VALUE ENGINEERING WORKSHOP REPORT (DRAFT)
for:
Florida Department of Transportation

South Sumter Trail
FPN: #435471-1

**RE: Value Engineering Study Report (Draft)
South Sumter Trail
FPN: #435471-1**

PROJECT:	South Sumter Trail FPN #: 435471-1	ALTERNATIVE NO.: S1-06
DESCRIPTION:	Install Hand Cranked Ferry To Cross River	SHEET NO.: 2 of 4

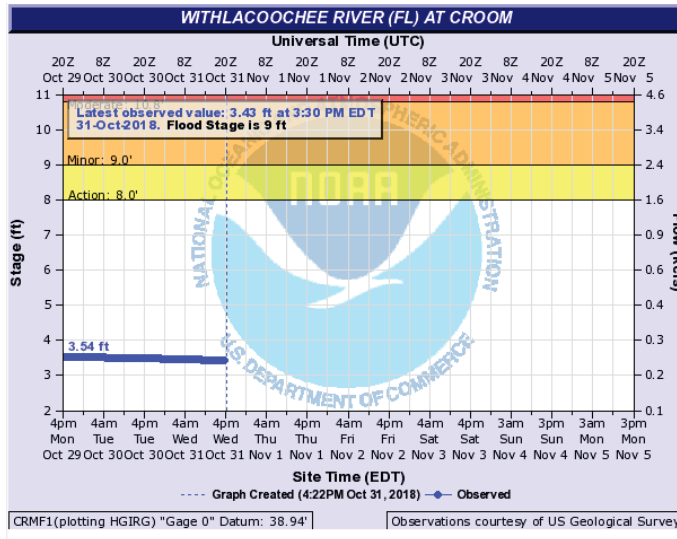
As seen in this clip taken from the gauge at Croom, the Withlacoochee is a shallow stream. The depth range is wide, with flood stages over 11'. Accordingly, a flat bottom or pontoon ferry would be most adaptable to a wide range of water depths.

PROJECT:	South Sumter Trail FPN #: 435471-1	ALTERNATIVE NO.: S1-07
DESCRIPTION:	Construct Steel Truss Bridge To Retain Historic Significance	SHEET NO.: 3 of 5

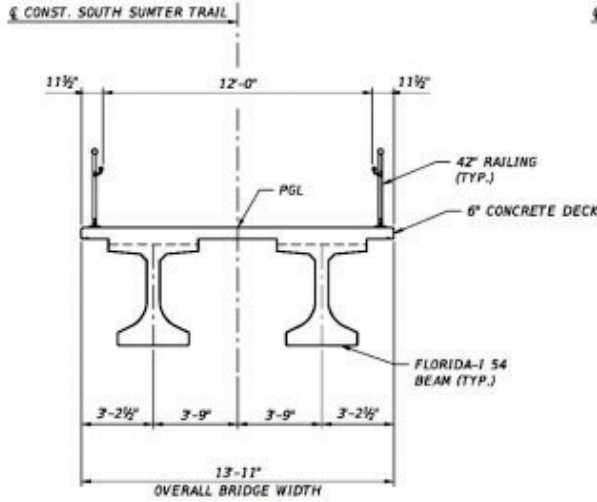
PROJECT:	South Sumter Trail FPN #: 435471-1	ALTERNATIVE NO.: S1-07
DESCRIPTION:	Construct Steel Truss Bridge To Retain Historic Significance	SHEET NO.: 2 of 5
<p>TECHNICAL DISCUSSION:</p> <p>Multiple variations of this alternative were discussed and considered. A technical summary of each variation, including the preferred alternative, is included below.</p> <p>Preferred Alternative S1-07 – Construct Steel Truss Bridge to Retain Historic Significance:</p> <p>The preferred alternative is to construct a steel truss bridge over the Withlacoochee River. There are several pre-fabricated steel truss bridge options such as those offered by Contech which would achieve the desired outcome of this alternative. The goal of the alternative is to recreate the appearance of the historic Iron Bridge crossing and provide an opportunity to relate the new structure to the history of the location. Prefabricated steel truss bridges are customizable to the geometric constraints of the project. For this particular location, clear width and height of the structure should allow for pedestrian and equestrian users. The stability and optics of a steel truss span are favorable for an equestrian crossing. A span length of approximately 160ft will be able to clear the river without having substructure elements in the river. The final skew of the crossing could impact the required length to span the river. These span lengths are easily achievable with prefabricated steel truss options.</p> <p>Alternative Variation S1-08 – Construct Suspension Bridge Across River:</p> <p>This alternative variation is to construct a suspension bridge over the Withlacoochee River. The goal of the alternative is to create a visually appealing signature structure at the river crossing. For this particular location, clear width and height of the structure should allow for pedestrian and equestrian users. The stability and optics of a suspension bridge are perceived to be unfavorable for an equestrian crossing. A span length of approximately 160ft will be able to clear the river without having substructure elements in the river. The final skew of the crossing could impact the required length to span the river. These span lengths are easily achievable with suspension bridge options.</p> <p>Alternative Variation S1-09- Construct Timber Bridge Across River:</p> <p>This alternative variation is to construct a timber bridge over the Withlacoochee River. The goal of the alternative is to create a visually appealing signature structure at the river crossing. For this particular location, clear width and height of the structure should allow for pedestrian and equestrian users. The stability and optics of a timber bridge are favorable for an equestrian crossing. A span length of approximately 160ft will be able to clear the river without having substructure elements in the river. These span lengths may be difficult to achieve with a timber structure.</p>

PROJECT:	South Sumter Trail FPN #: 435471-1	ALTERNATIVE NO.: S1-18
DESCRIPTION:	Realign Trail Along CR 674/CR 654A	SHEET NO.: 3 of 5

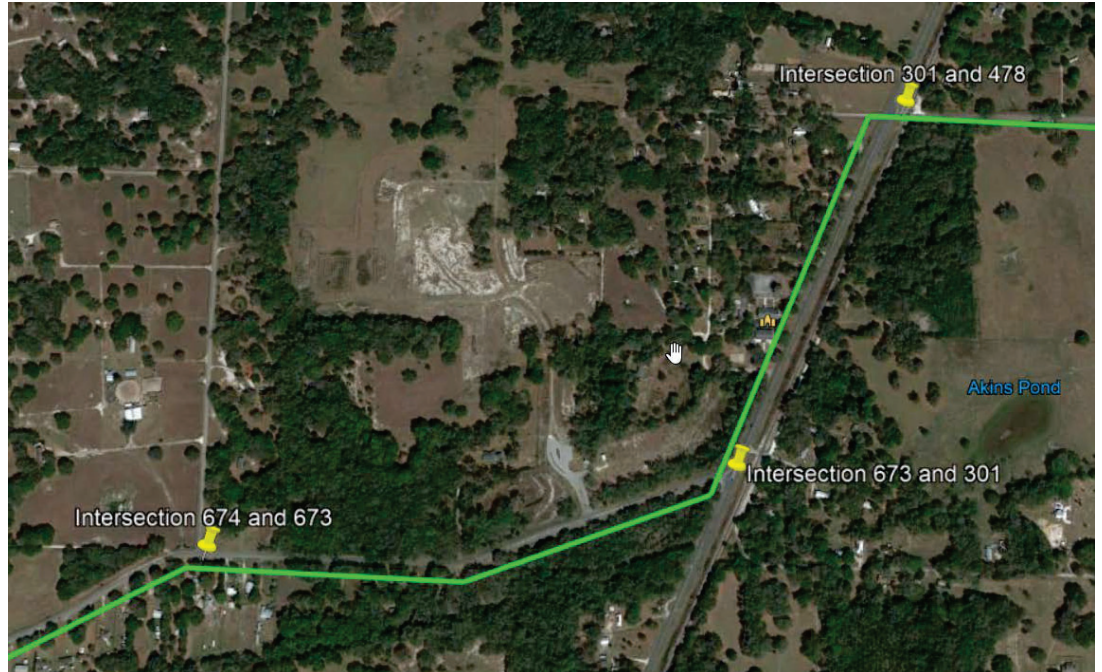
PROJECT:	South Sumter Trail FPN #: 435471-1	ALTERNATIVE NO.: S1-18		
DESCRIPTION:	Realign Trail Along CR 674/CR 654A	SHEET NO.: 1 of 5		
ORIGINAL DESIGN: The original design calls for the trail to follow along CR 673 to US 301 then cross to follow CR 478 west.				
ALTERNATIVE: The alternative design suggests turning left from CR 673 to travel north on CR 674 then make a right on to CR 654A. Follow CR 654A across US 301 into CR 478.				
OPPORTUNITIES:	RISKS:			
<ul style="list-style-type: none"> • REDUCES THE HAZARDS OF CROSSING US 301 AT CR 673 • ELIMINATE ROW ACQUISITION FROM CHURCHES • MORE SCENIC ROUTE FROM CYCLISTS • ELIMINATES RIDING ALONGSIDE THE RAIL 	<ul style="list-style-type: none"> • 4-6 PARCEL IMPACTS ON CR 654A • MULTIPLE PARCELS IMPACTED ALONG CR 674 			
CATEGORIES:				
<input checked="" type="checkbox"/> Safety	<input checked="" type="checkbox"/> Operations	<input checked="" type="checkbox"/> Environment	<input checked="" type="checkbox"/> Construction	Other

PROJECT:	South Sumter Trail FPN #: 435471-1	ALTERNATIVE NO.: S1-20
DESCRIPTION:	Selectively Build Box Culvert/Trail/Ditch Combination	SHEET NO.: 3 of 5

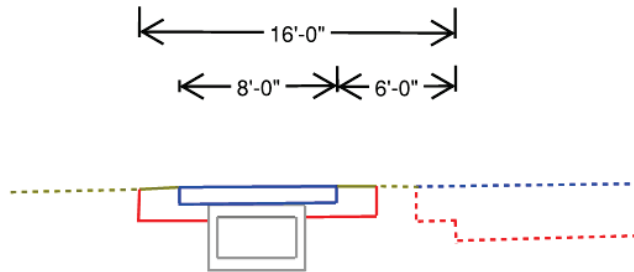
In areas where the planned alignment is interrupted by an unwilling seller, it would be possible to use a box culvert (2' high by 4' wide) to convey the ditch flow and have the trail run on top of the culvert. This would eliminate the need for right of way and allow the trail to continue past the unwilling seller's property. An example property is shown in the illustrations and used to analyze potential impacts and savings.

Showing 17' of Right of Way from edge of travel lane, with a 39' take for 335' across the property.

Trail can ride on top of culvert and fit within the available space. Suggest 5' transition on either side of the property that is avoided.

PROJECT:	South Sumter Trail FPN #: 435471-1	ALTERNATIVE NO.: SI-21
DESCRIPTION:	Build 8' Path On One Side And 8' Path On Other Side In Future	SHEET NO.: 3 of 4

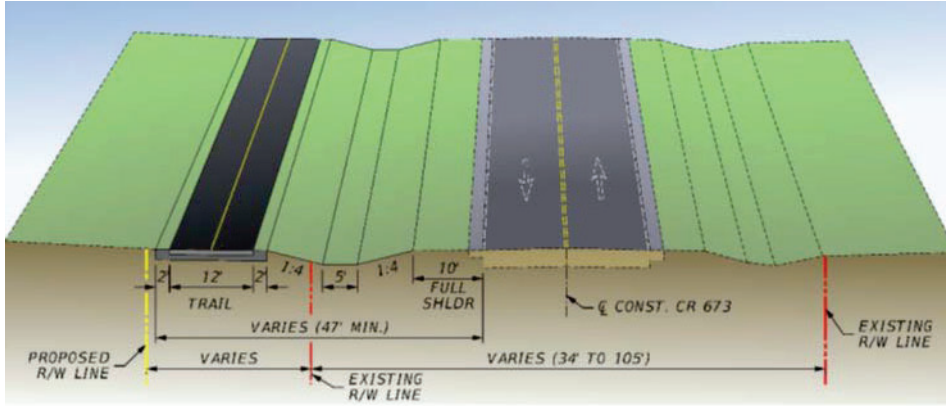
PROJECT:	South Sumter Trail FPN #: 435471-1	ALTERNATIVE NO.: S1-21
DESCRIPTION:	Build 8' Path On One Side And 8' Path On Other Side In Future	SHEET NO.: 2 of 4
<p>TECHNICAL DISCUSSION:</p> <p>This Phased approach allows earlier scheduling for a shorter-term activity. The resulting unidirectional side paths are operationally safer for riders. It is some cyclists preference to use side paths. Side path design is fairly advanced so there are advantages in improved design that can be deployed.</p> <p>One iteration of dedicated bicycle routes includes construction of side paths along public roads. Typically side paths are intended as unidirectional facilities where all users travel in the same direction parallel to the adjoining travel lane. Side paths may be slightly elevated behind a raised ribbon curbing.</p> <p>This recommendation is to build the project in two phases. The first phase would be an 8' side path that for a time would serve as a bi-directional facility. At a later (defined) date, as Phase II a second side path would be built along the other side of the roadway. The result would be two parallel cycling paths (tracks), serving opposite directions.</p> <p>A major safety issue with bidirectional side paths along a road is conflict points at intersections where cyclists approaching from the downstream direction are not noticed by drivers. Where side paths are wider, oncoming cyclists are exposed to a wider crossing location where vehicles are likely to dwell on the path and impede crossing cyclists. A narrower side path where cyclists are traveling in the same direction as main stream traffic is somewhat less likely to result in intersection conflicts.</p> <p>Phased construction may cost somewhat more due to need for additional mobilization.</p>

PROJECT:	South Sumter Trail FPN #: 435471-1	ALTERNATIVE NO.: S3-01
DESCRIPTION:	Construct Roundabout At CR 478/ CR 471	SHEET NO.: 3 of 5

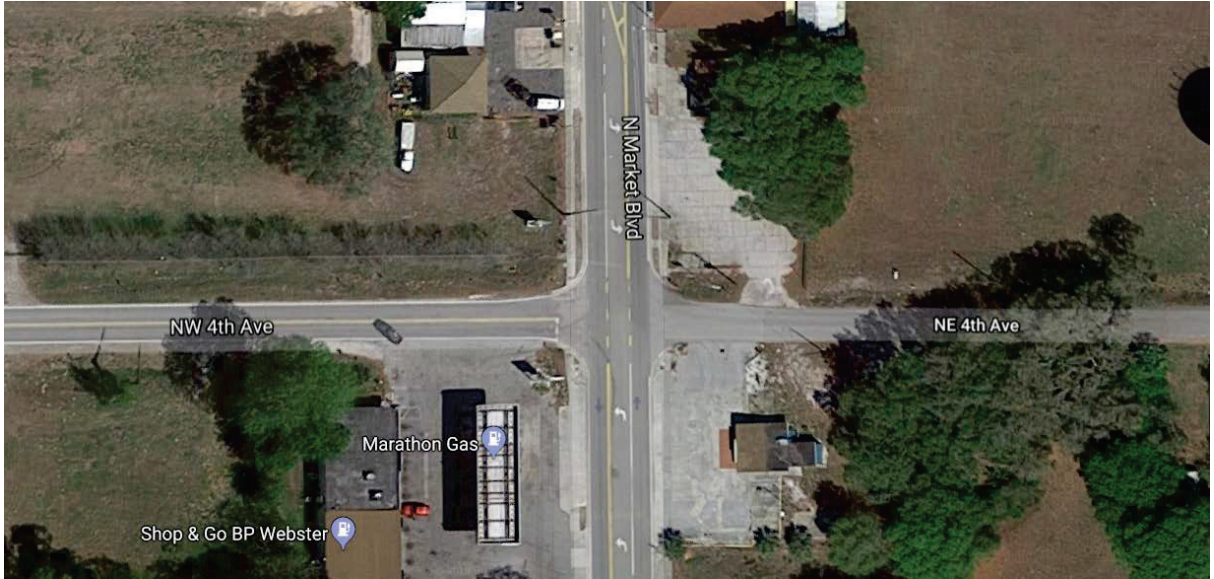
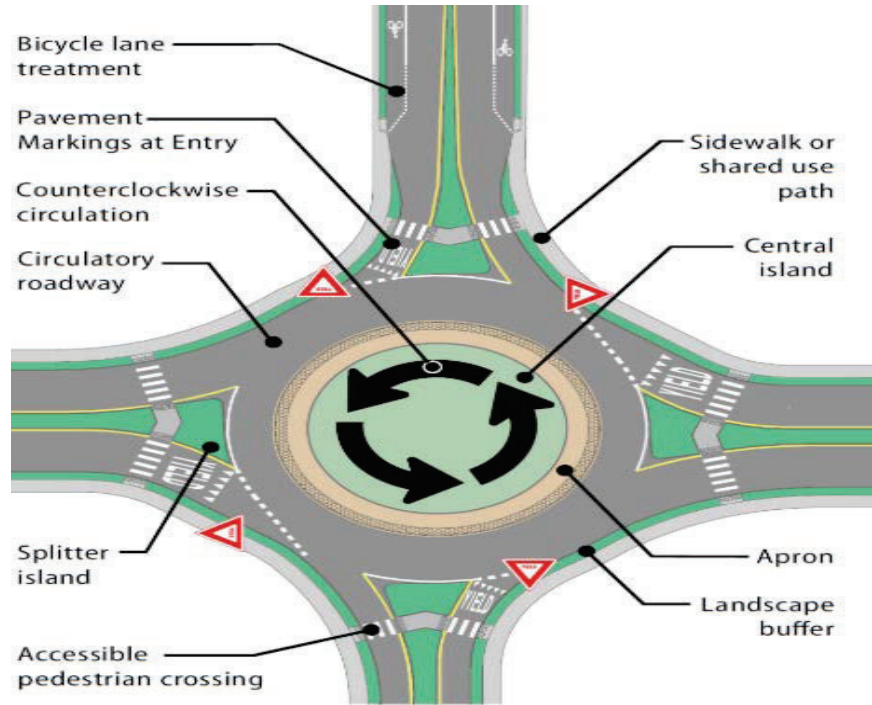
This alternative will provide a safer, more efficient intersection. It is also more aesthetically appealing than the existing intersection.

ORIGINAL DESIGN: THE ORIGINAL DESIGN DOES NOT INCLUDE A ROUNDABOUT.

PROJECT:	South Sumter Trail FPN #: 435471-1	ALTERNATIVE NO.: 03-02
DESCRIPTION:	Provide Trail On Both Sides At Flea Market With Multiple Crossings.	SHEET NO.: 3 of 5

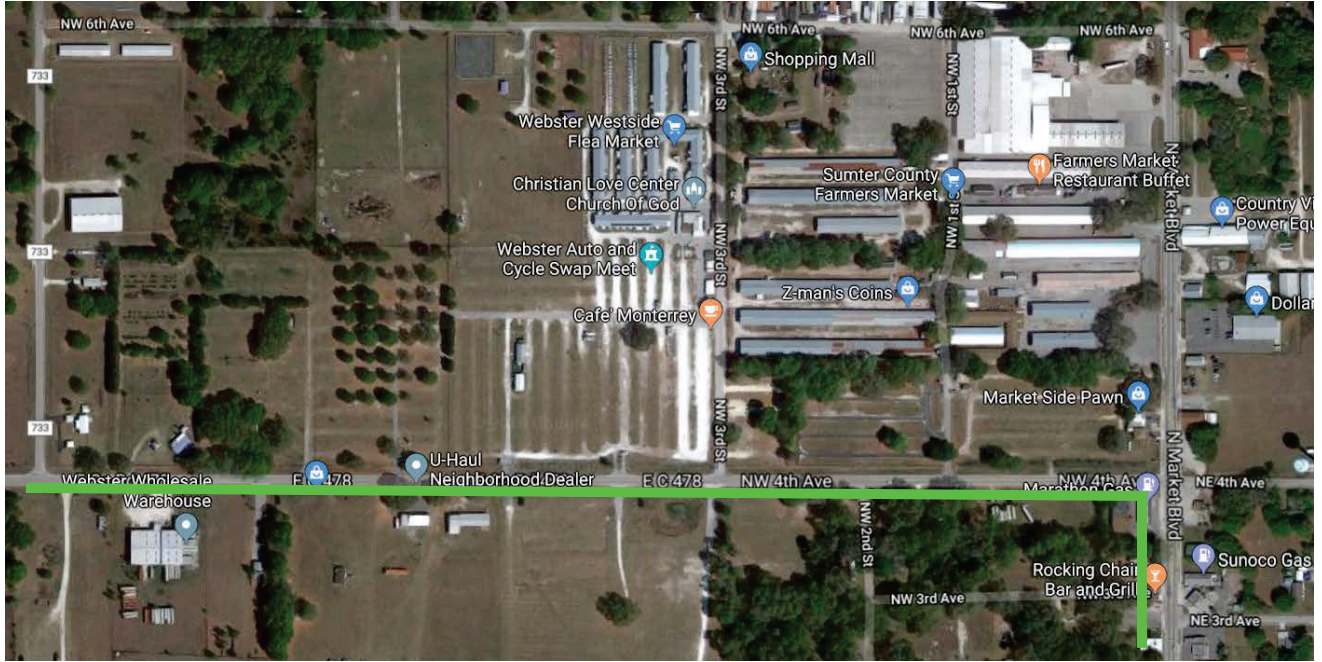
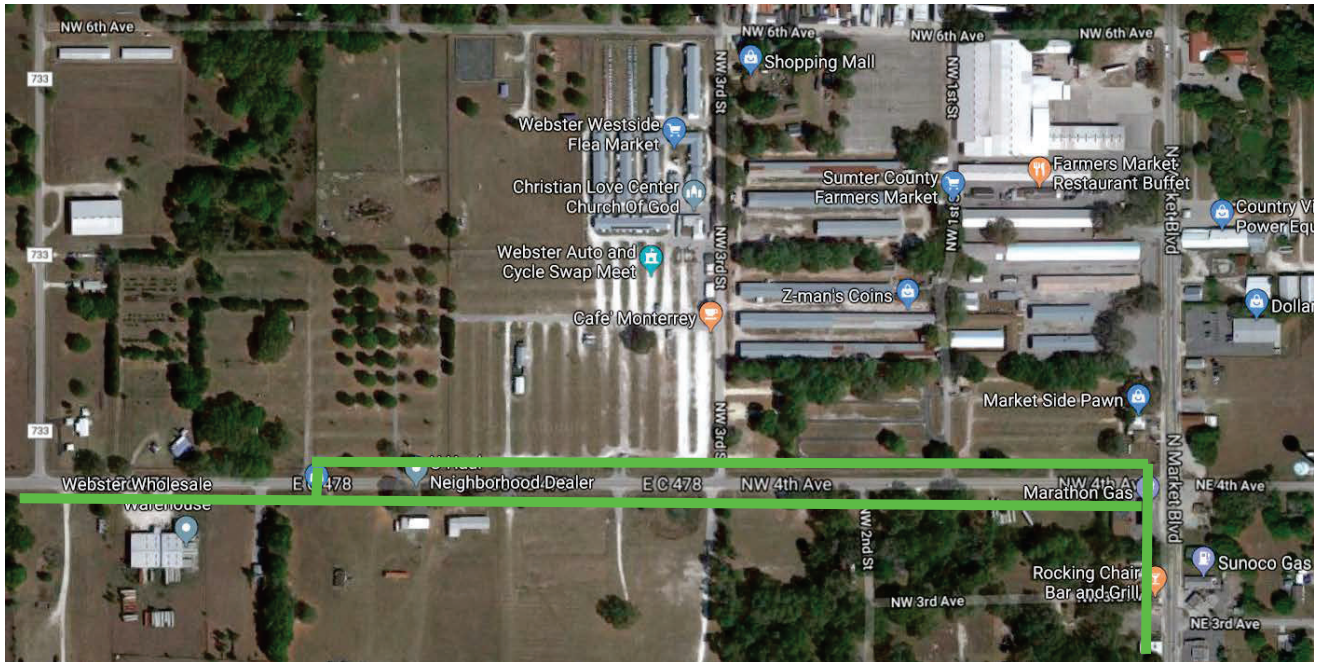
PROJECT:	South Sumter Trail FPN #: 435471-1	ALTERNATIVE NO.: S3-02
DESCRIPTION:	Provide Trail On Both Sides At Flea Market With Multiple Crossings	SHEET NO.: 2 of 5

PROJECT:	South Sumter Trail FPN #: 435471-1	ALTERNATIVE NO.: S3-03
DESCRIPTION:	Realign Trail To Avoid Downtown Webster But Spur Up To Flea Market	SHEET NO.: 3 of 6

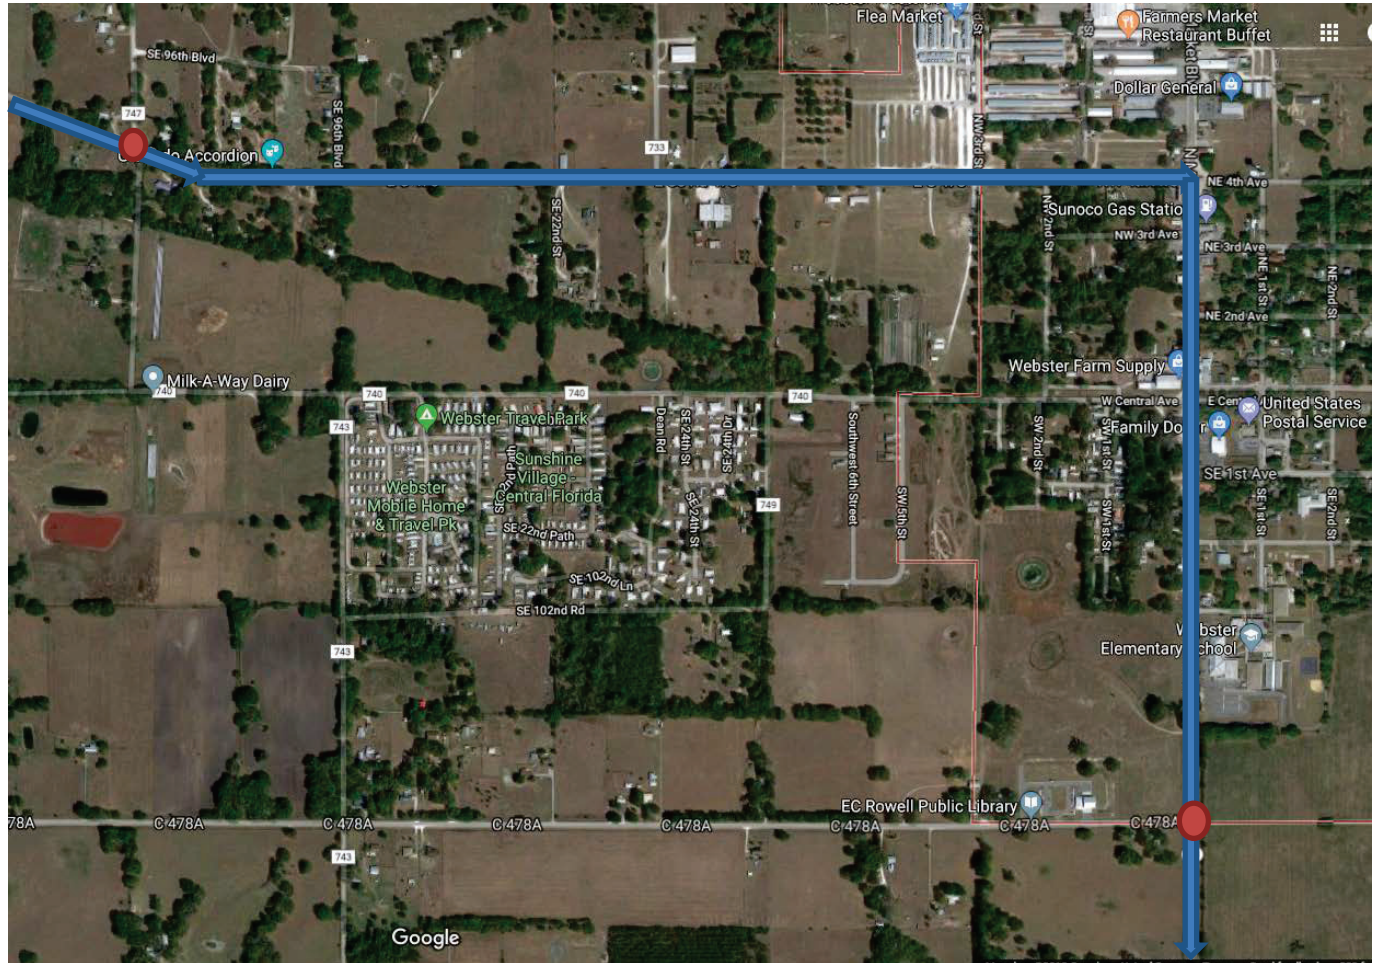
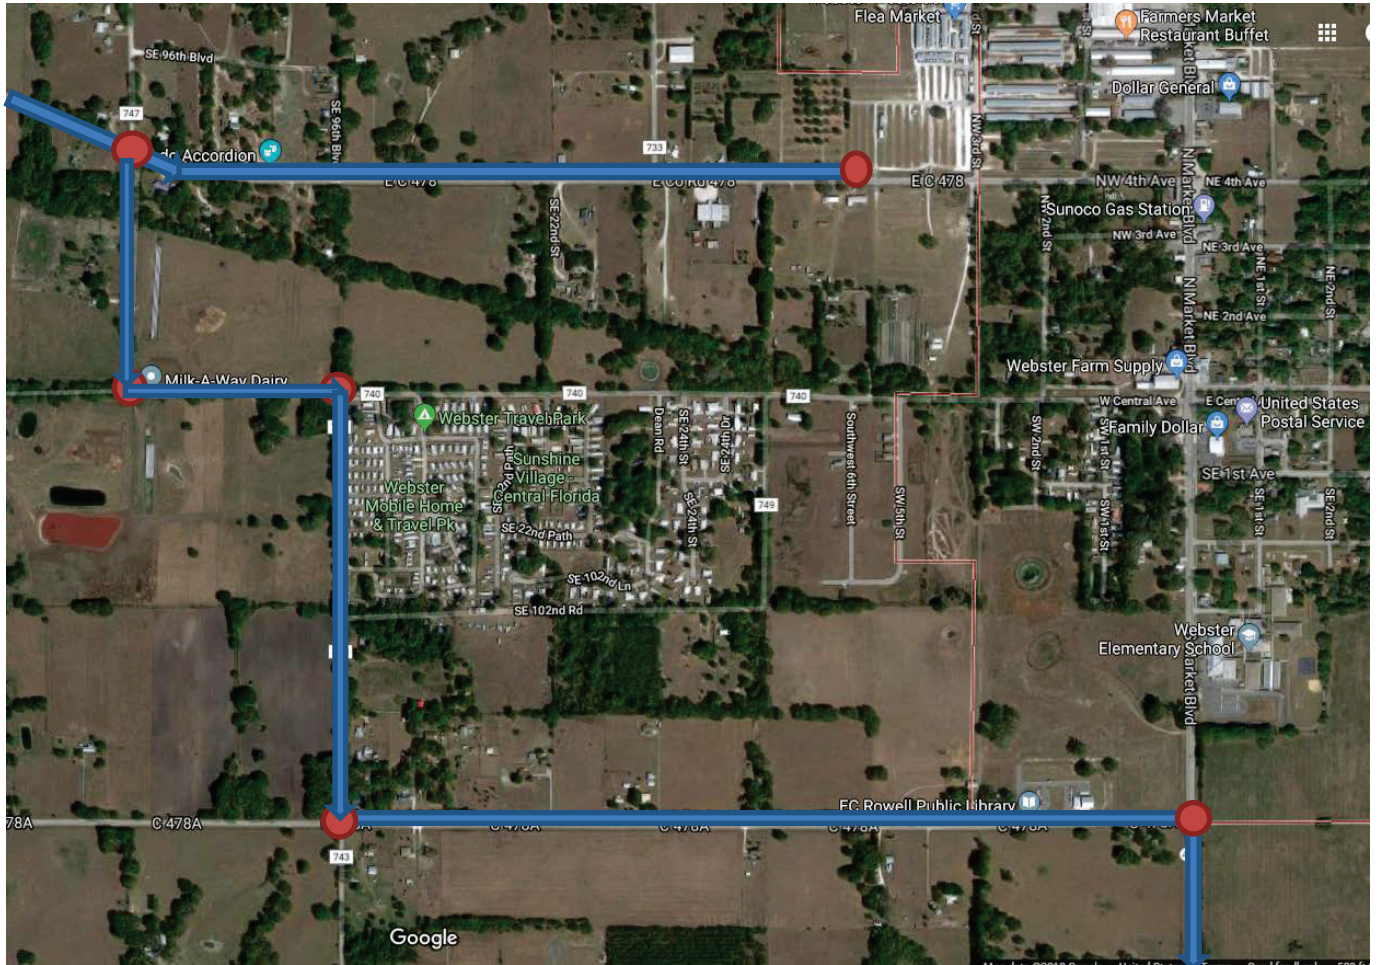
PROJECT:	South Sumter Trail FPN #: 435471-1	ALTERNATIVE NO.: S3-03
DESCRIPTION:	Realign Trail To Avoid Downtown Webster But Spur Up To The Flea Market	SHEET NO.: 2 of 6
<p>TECHNICAL DISCUSSION:</p> <p>This alternative involves a route that would bypass the commercial section of the town of Webster. The proposed alternative would provide a spur that would reach as far as the Webster Flea Market, but not proceed to the intersection of CR 478 and SR 471. The proposed alternative would proceed with a mainline down CR 747 from CR 478 then east on CR 740, then south on CR 743, then east on CR 478A to connect to SR 471 just south of the School.</p> <p>The original alternative would cover a length of approximately 9,228 linear feet to go from CR 747 to the intersection of SR 471 and CR 478A. The proposed alternative would require approximately 15,155 linear feet. This would result in an increase of 5,927 linear feet in construction costs.</p> <p>Additional costs for Right of Way are not possible to calculate without knowledge of road widths and design requirements along the proposed route. However, it should be noted that even though there are more parcels and a longer route it would avoid potentially costly commercial properties in the Original design.</p>

LENGTH: 9,228 FEET BETWEEN CR 747 AND CR 478A INTERSECTION

Length: 15,155 feet between CR 747 Intersection with CR 478 and CR 478A Intersection with SR 471 plus Spur from CR 747 to the Webster Flea Market.
